Access Compliance Report

Public Rights-of-Way

Intersection ID: 53633	Main Street: TREMONT_RIDGE_CT	Cross Street: BEACON_VALLEY_ST	Location: SW
ADA ID: 219A28BF5842	Ramp Type: PerpDiag	Initial Pass/Fail: Fail	Overall Compliance: No
Severity Score: 33.75			
Codes/Mitigation Info/Possible Solution		Field Measurements/Component Compliance

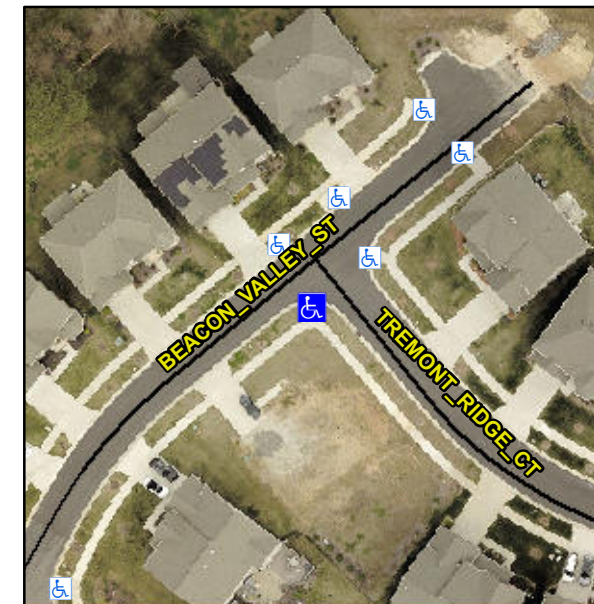
Not Found, R304.5.1, R304.5.3

Compliance	Description	Data	Compliance	Description	Data
N/A	Ramp Length (in)	95.0	Yes	Ramp Slope (%)	6.6
No	Ramp Width (in)	45.5	No	Ramp XSlope (%)	9.9
N/A	Flare Type LT	N/A	N/A	Flare Type RT	N/A
N/A	Flare Slope LT (%)	N/A	N/A	Flare Slope RT (%)	N/A
N/A	Flare Traversable LT?	N/A	N/A	Flare Traversable RT?	N/A
N/A	Landing Length (in)	N/A	N/A	DWS Provided?	N/A
N/A	Landing Width (in)	N/A	N/A	DWS Contrast?	N/A
N/A	Landing Slope (%)	N/A	N/A	DWS Length (in)	N/A
N/A	Landing X Slope (%)	N/A	N/A	DWS Full Width?	N/A
N/A	Landing Curb? (Y/N)	N/A	N/A	DWS Offset (in)	N/A
N/A	Shared Landing?	N/A			
N/A	Gutter Ponding?	N/A	N/A	Gutter Slope (%)	N/A
N/A	Gutter Lip Ht (in)	N/A	N/A	Gutter X Slope (%)	N/A
N/A	Painted X Walk1?	No	N/A	Painted X Walk2?	No
	X Walk 1 Direction	To NE		X Walk 2 Direction	To NW
N/A	X Walk 1 Width (in)	N/A	N/A	X Walk 2 Width (in)	N/A
	X Walk 1 Slope (%)	8.8		X Walk 2 Slope (%)	4.9
	X Walk 1 X Slope (%)	2.7		X Walk 2 X Slope (%)	9.0

Remove & Replace Curb Ramp With Two New Directional Ramps or Equivalent.
